# City of Oakley ADDENDUM NO. 2 to contract documents for STORM DRAIN IMPROVEMENT PROJECT, CIP # 183

Notice is hereby given that the following clarifications and revisions are made to the above referenced contract documents:

# Plan Sheet 3 Updates

2

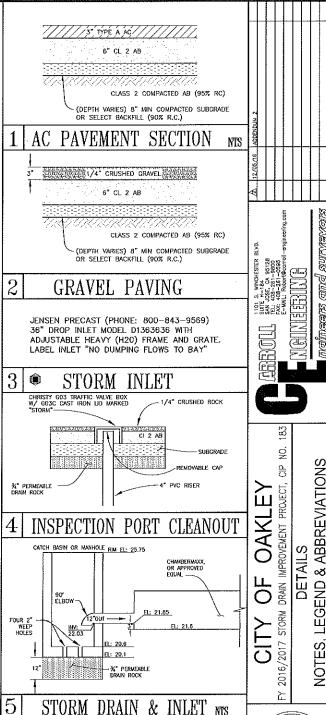
- 1) Notes 3, 25, 27, and 28 are removed from the Sheet 3 of the Plans.
- 2) Contractor to install PVC coated copper service line per Diablo Water District Note 11 on Sheet 3 of the Plans

- 11. USE MUFILER STREAMLINE PVC COATED COPPER FOR SERVICE LINE AND ARY PIPING.
- 12. CONTRACTOR SHALL INSTALL CURB STOPS AND METER BOXES ACCEPTABLE TO DIABLO WATER DISTRICT AT EACH LOT HIMEDIATELY PRIOR TO JUMPER BEING REMOVED. AT THE EXPENSE OF THE DEVELOPER/CONTRACTOR, PAD LOCKS WILL BE INSTALLED BY DIABLO WATER DISTRICT AT EACH ANGLE STOP.
